Technical News 163

April 2015

Contents

Item 2.

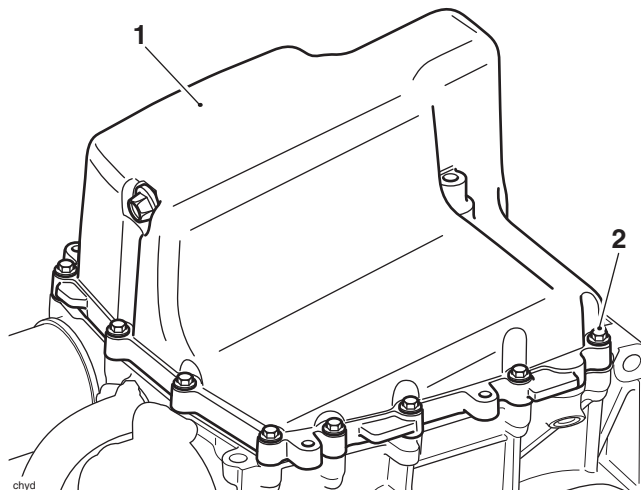
The torque figure for the sump fixings has changed to **10 Nm** on the above models.

- Models already in service need not be retightened unless the fixings have been loosened or removed.

Item 3.

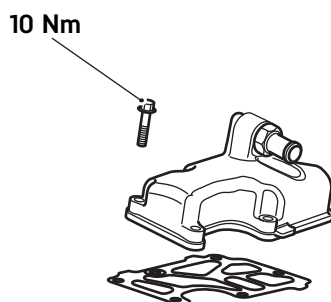
The torque figure for the crankcase breather cover bolts has changed to **10 Nm** on the above models.

- Models already in service need not be retightened unless the fixings have been loosened or removed.

Item 5.

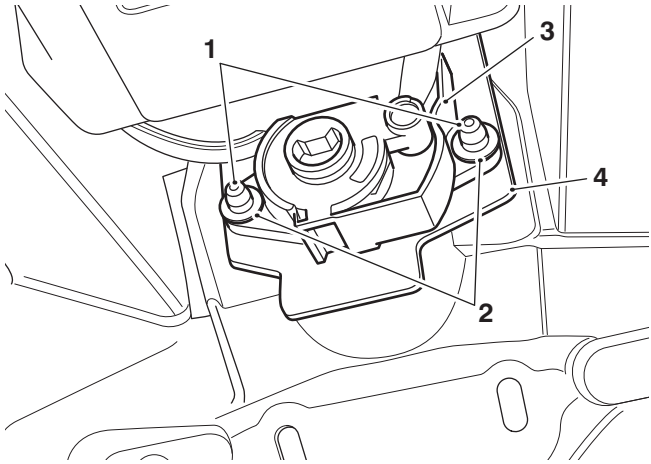
A revised washer has been introduced on the above models from VIN 708953 and is retrofittable. The thicker washer allows the rivet to achieve a tighter fixing between the seat lock and its bracket. If the seat lock is removed or replaced for any reason, one thicker 11 x 1.6 mm washer is to be used with a new 4.8 x 18 mm rivet.

- **Models already in service need not be replaced unless the seat lock has been loosened or removed.**

Item 7.

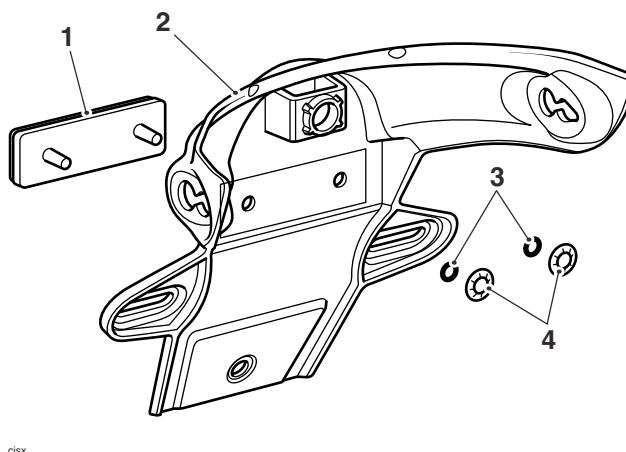
O-rings have been introduced to the rear reflector mountings on the above models from VIN 702714. The new O-rings are retrofittable to the above models.

1. Position the rear reflector to the registration plate moulding and secure using the rubber O-rings and the retaining washers as shown below.

Item 8.

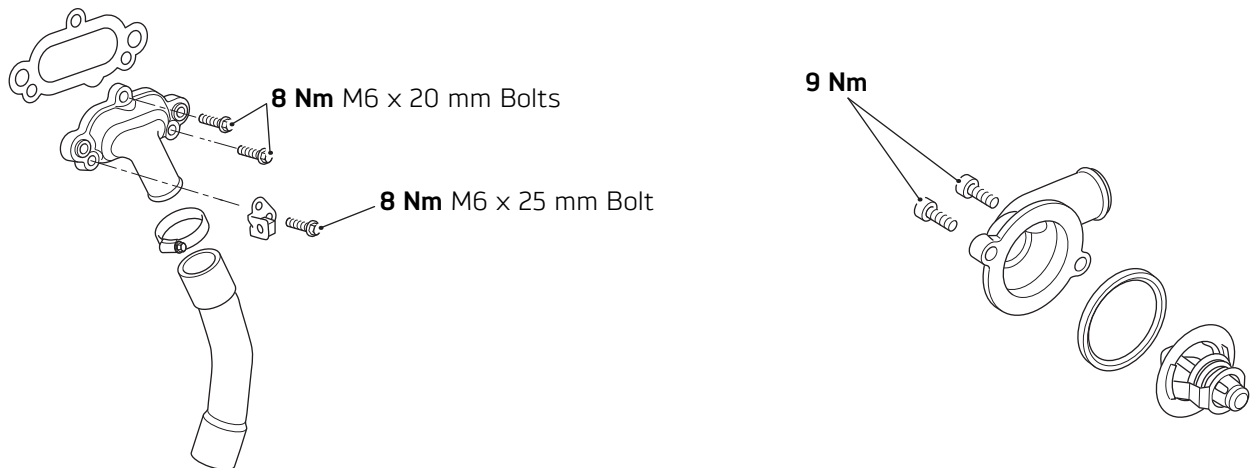
The torque figure for the M6 x 1.0 mm x 25 mm water inlet cover bolt has changed to **8 Nm** on the above models. The torque figure of **8 Nm** is unchanged for the remaining two M6 x 1.0 mm x 20 mm water inlet cover bolts.

The torque figure for the water outlet cover bolts has also changed to **9 Nm**.

- **Models already in service need not be retightened unless the fixings have been loosened or removed.**
